ITEM FOR ENVIRONMENTAL COMMISSION AGENDA

NAME & NUMBER OF PROJECT: Oltorf Site Plan (SP-2021-0091C)

REQUEST: Variance request is as follows:
Request to vary from LDC 25-8-301 to allow driveways on slopes over 15%.
Request to vary from LDC 25-8-341 to allow cut over 4 feet up to 8 feet.
Request to vary from LDC 25-8-342 to allow fill over 4 feet up to 20.5 feet.

**Variance Requests from LDC 25-8-301, LDC 25-8-341 and LDC 25-8-342
Associated with SP-2021-0091C, 4544 E Oltorf**

CUT/FILL EXHIBIT

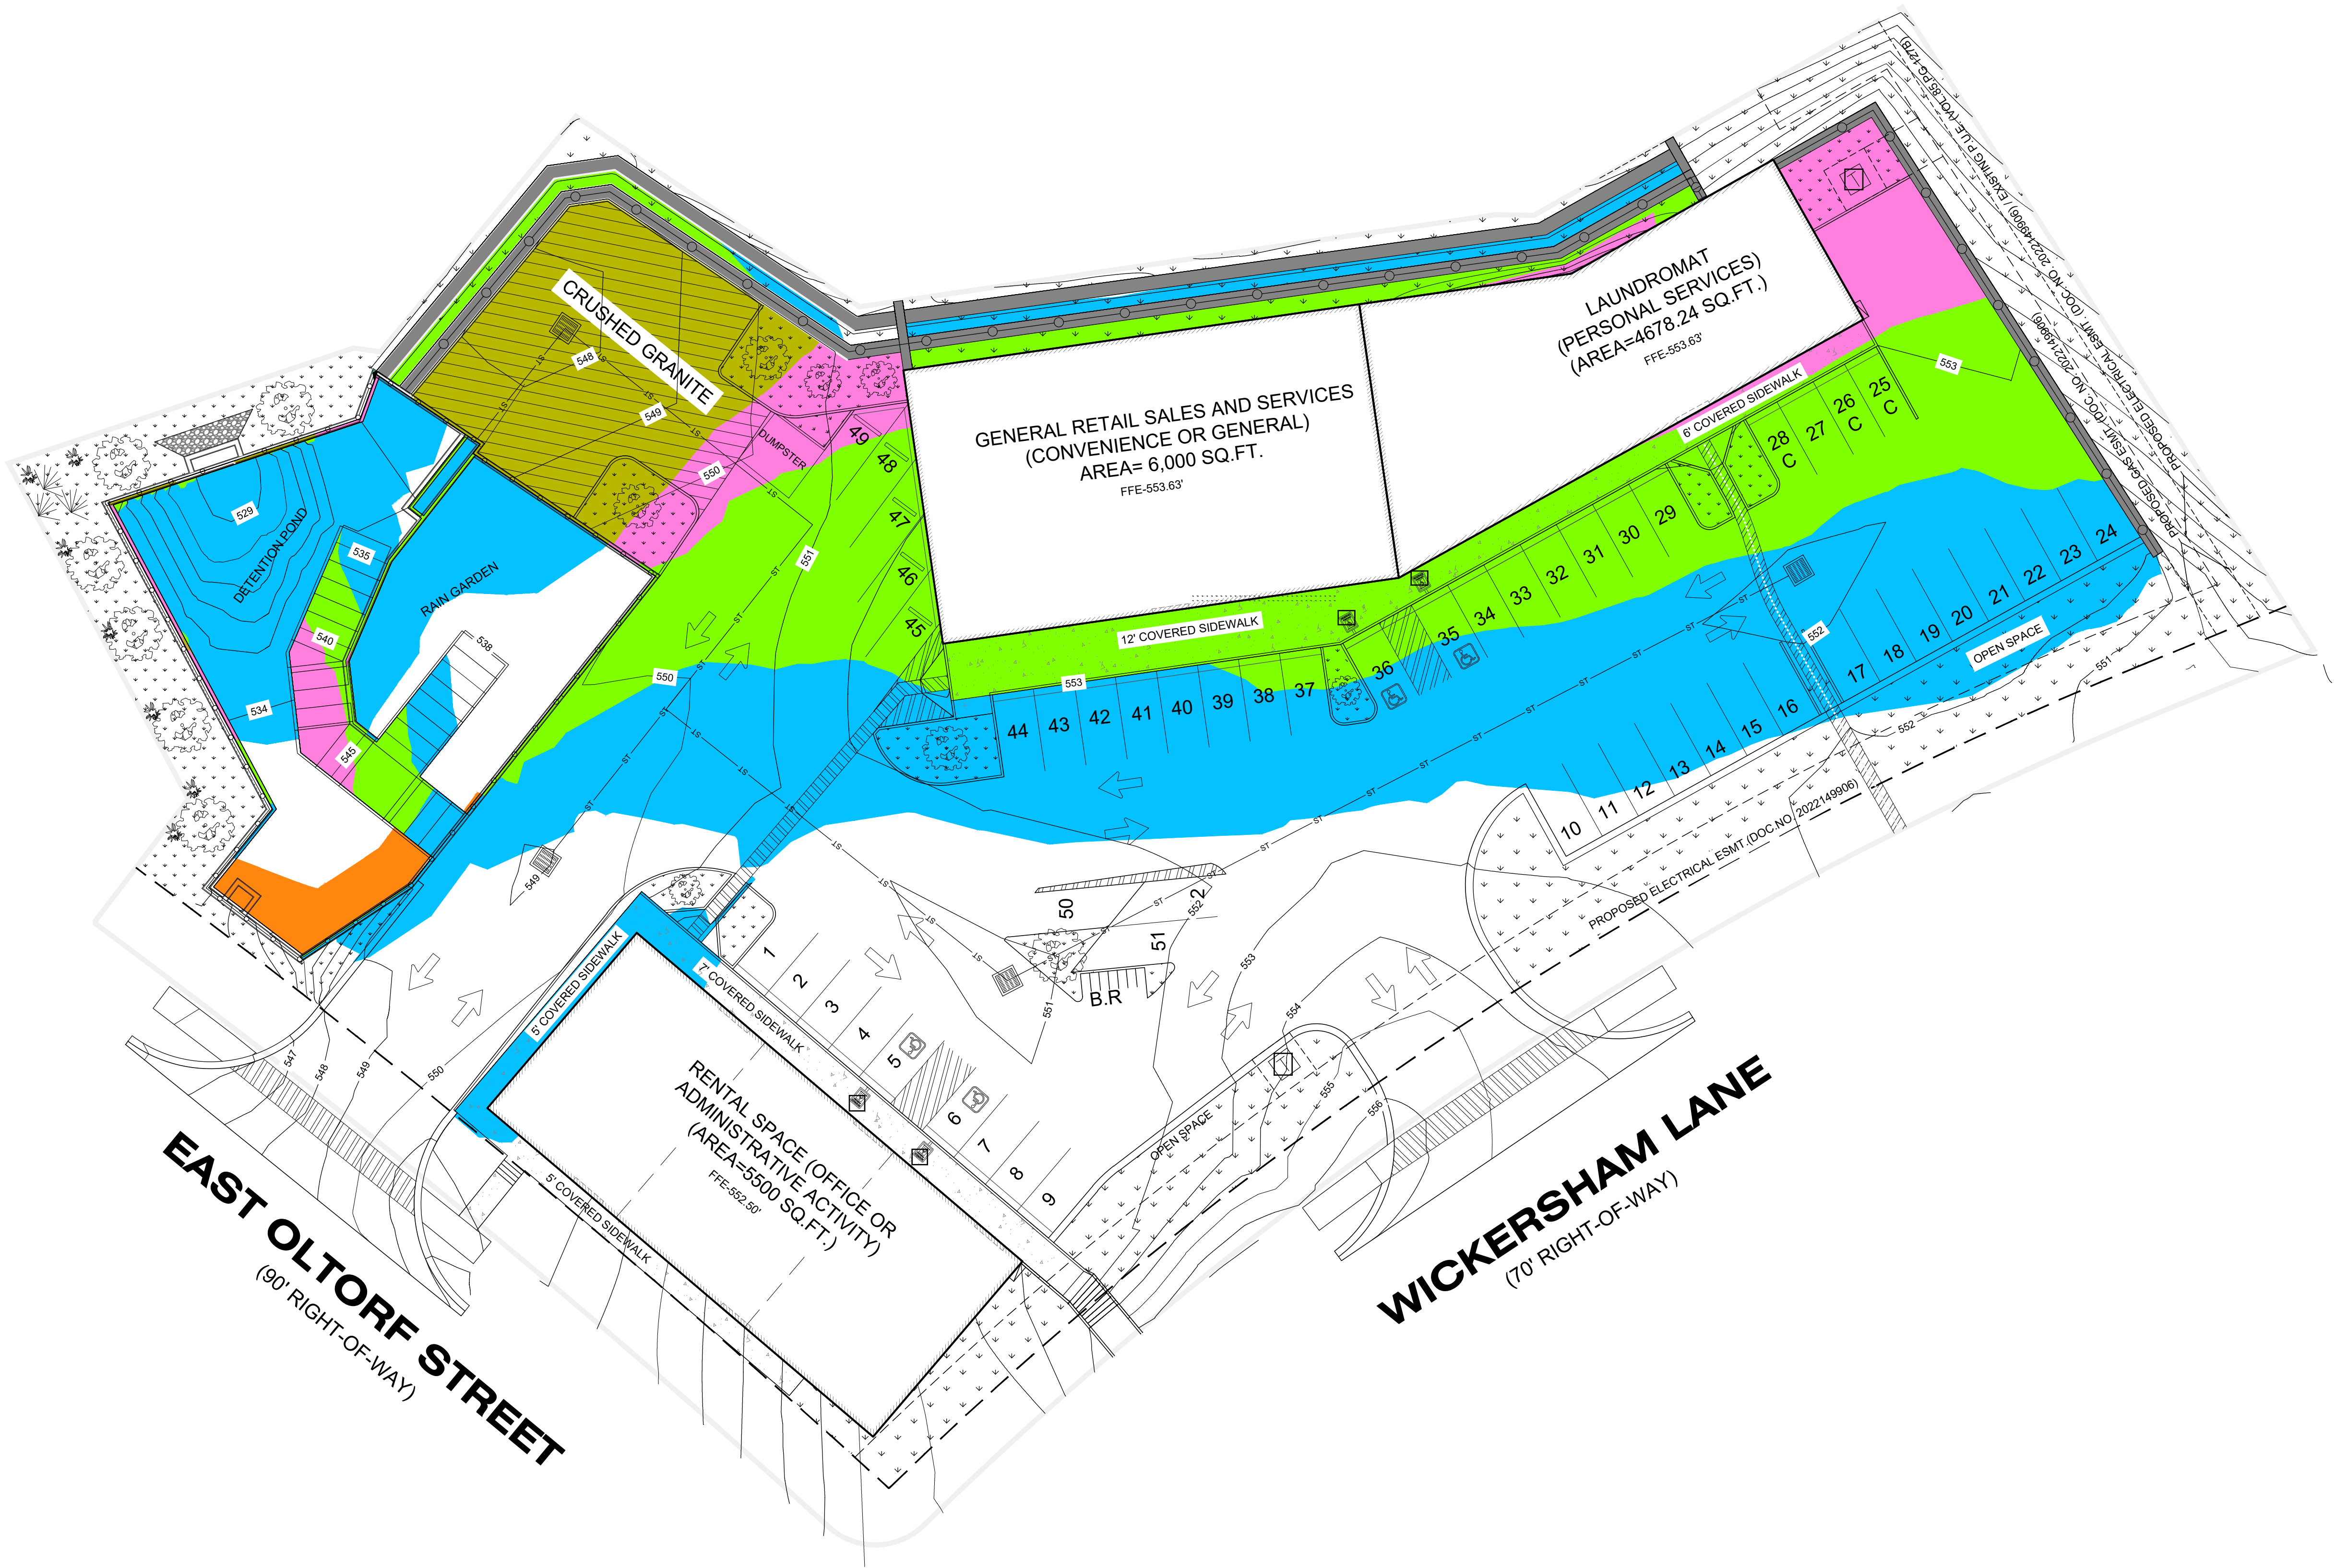
Yes. The variance does not create a significant probability of harmful environmental consequences. The variance is a minimum deviation from code to allow for reasonable use of the property. Fill will be minimized and structurally contained with retaining walls.

- Provide 8 additional trees at 3 caliper inches.
- Provide structural containment of fill with retaining walls.
